Subject: Mixed Waste Pond Closure Project
Field Change No. 016

BP CHEMICALS, INC.
MIXED WASTE POND CLOSURE PROJECT

Subject: French Drain for West Side of Cell No. 1

Subject: Design of Anchor Trench with French Drain

- PROPOSED FRENCH DRAIN/ANCHOR TRENCH SECTION

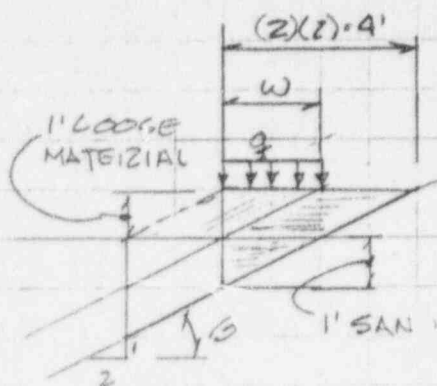
Description: CONSTRUCT ANCHOR TRENCH ALONG WEST EDGE OF
V-1 CELL IN ACCORDANCE WITH SKETCH ON
SHEET 2 OF ATTACHED CALCULATION BUF-96-112.
LOCATE INVERT OF DRAIN AND COLLECTION SUMP
IN ACCORDANCE WITH ATTACHED SKETCHES. PROVIDE
CLEANOUT AT EACH END PER ATTACHED SKETCH.

Justification: FRENCH DRAIN IS REQUIRED TO INTERCEPT
SHALLOW GROUNDWATER TO PREVENT LEAKAGE UNDER
LINER. REVISED ANCHOR TRENCH DESIGN MAINTAINS
ADEQUATE STABILITY AS IS SHOWN BY ATTACHED
CALCULATIONS.

1. CLEAN AND DRESS EXCAVATION
2. PLACE BOTTOM GEOMEMBRANE*
3. PLACE AND COMPACT A 6" THICK (COMPACTED) LAYER OF CLAY BETWEEN INSIDE OF ANCHOR TRENCH AND OUTSIDE EXCAVATION LIMITS
4. PLACE BOTTOM GEONET*
5. PLACE AND COMPACT A 6" THICK LAYER OF CLAY PER STEP 3.
6. PLACE UPPER GEOMEMBRANE*
7. PLACE AND COMPACT A 6" THICK LAYER OF CLAY PER STEP 3.
8. PLACE UPPER GEONET.*
9. PLACE AND COMPACT A 6" THICK LAYER OF CLAY PER STEP 3.
10. EXCAVATE 2' (MIN.) BENCH AT OUTSIDE EDGE OF ANCHOR TRENCH.
11. EXCAVATE 2' WIDE TRENCH TO ELEVATION SHOWN ON PLAN
12. PLACE GEOTEXTILE STARTING AT OUTSIDE OF ANCHOR TRENCH. PLACE LINER IN 2 FT. WIDE TRENCH SO IT CONFORMS TO TRENCH BOTTOM. KEEP GEOTEXTILE ROLLED IN ANCHOR TRENCH.

13. PLACE PIPE IN TRENCH AND BACKFILL TRENCH WITH STONE

14. PLACE GEOTEXTILE OVER STONE. NO SEAM REQ'D

15. MOVE GEOTEXTILE ROLL TO RUNNOUT AREA. PLACE AND COMPACT CLAY TO BACKFILL TRENCH TO GRADE

FRENCH DRAIN - V-1 CELL - FW

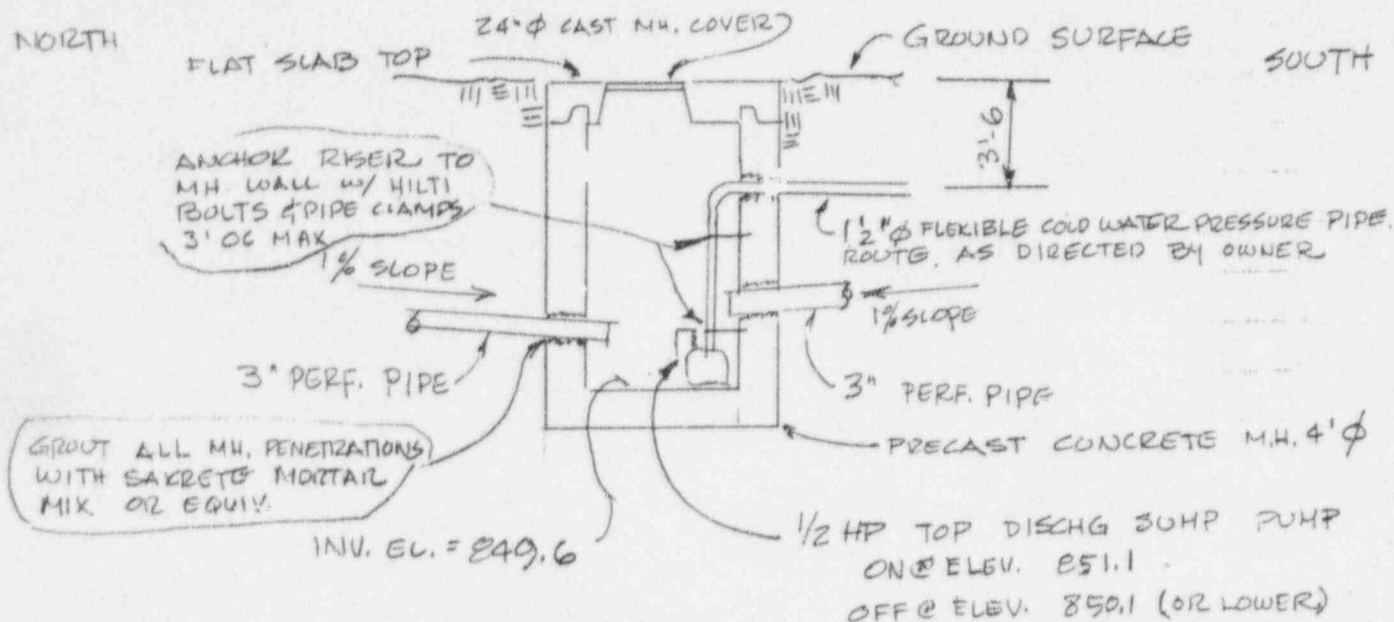
TERMINATE FR. DRAIN
IN 4' Ø (ID) PRECAST
CONCRETE MANHOLE
W/ FLAT SLAB TOP &
24" Ø OPENING
